# Independent Peer Review Panel

## IPRP Report No. 8, December 17, 2014

### **Comments on PG&E's Central Coastal California Seismic Imaging Project Report part 2: onshore seismic studies intended to reduce the uncertainty in seismic hazard at Diablo Canyon Power Plant**

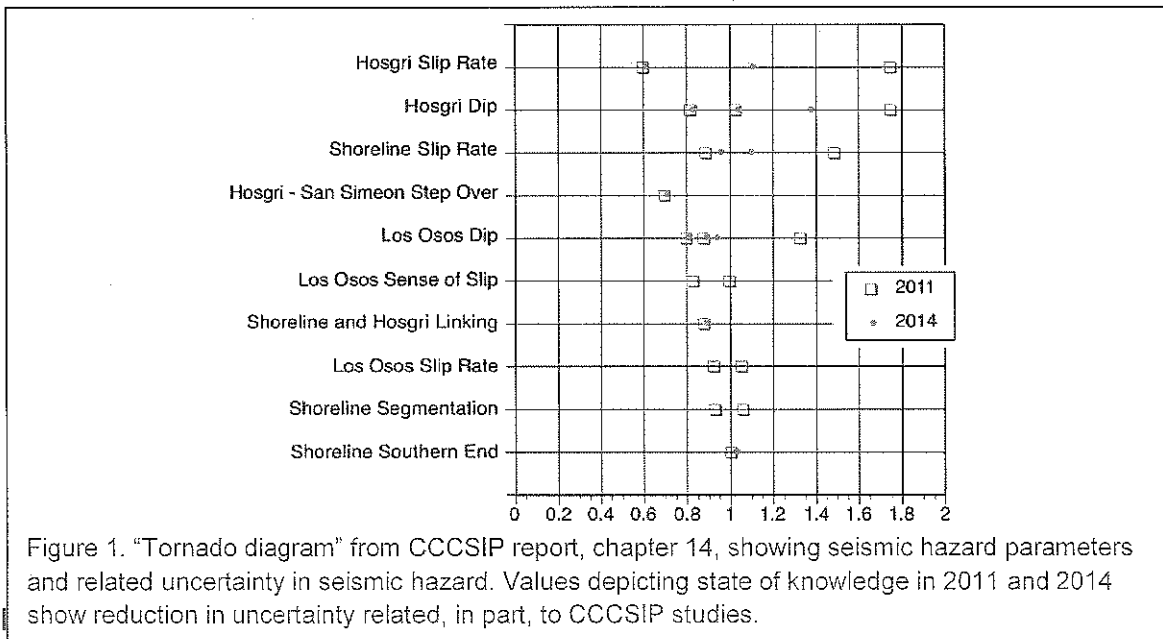
At the IPRP meeting on November 17, 2014, PG&E project manager Stuart Nishenko presented an update of the "tornado diagram" from the August 11, 2011 memo report. In the updated "tornado diagram" (Figure 1), the distance between points related to a hazard parameter represents the uncertainty in seismic hazard resulting from that parameter. In this type of diagram, parameters that are poorly constrained and have a

large effect on hazard are shown as widely separated points at the top of the diagram. Closely spaced points shown near the base of the diagram can be either parameters that are well-constrained or parameters that are poorly-constrained but have slight effect on hazard.

As stated by Dr. Nishenko, reducing the uncertainty in the parameters near the top of the “tornado” will have the greatest effect in reducing the uncertainty in hazard. The depiction of uncertainty in 2011 and 2014, particularly the lower uncertainty for the parameters at the top of the “tornado” show PG&E’s estimate of how much uncertainty in seismic hazard has decreased due to studies described in the CCCSIP report. The parameter with the greatest impact on seismic hazard, slip rate on the Hosgri fault, was the main subject of IPRP Report No. 7.

This report includes discussion of seismic hazard parameters including dip and sense of slip on the Los Osos fault (fourth and fifth from the top of the “tornado”). The IPRP notes that the parameters shown on the “tornado diagram” are the parameters included in the 2011 seismic hazard analysis. As stated in IPRP Reports No. 2 and 3, an important emphasis of on-land seismic surveys should be to determine if there are additional faults that should be considered and an overall “tectonic model” describing the location, sense of slip, and level of activity on faults within the Irish Hills.

As in IPRP Report No. 7, the IPRP notes that the parameters shown on the “tornado diagram” are all “seismic source characterization” parameters. Other parameters, especially “site conditions” or “site amplification” parameters can have equal or greater impact on seismic hazard calculations as any shown on Figure 1. Site conditions and seismic amplification factors were the subject of IPRP Report No. 6 and are discussed in other sections of the CCCSIP report. These factors will be addressed in a subsequent IPRP report.
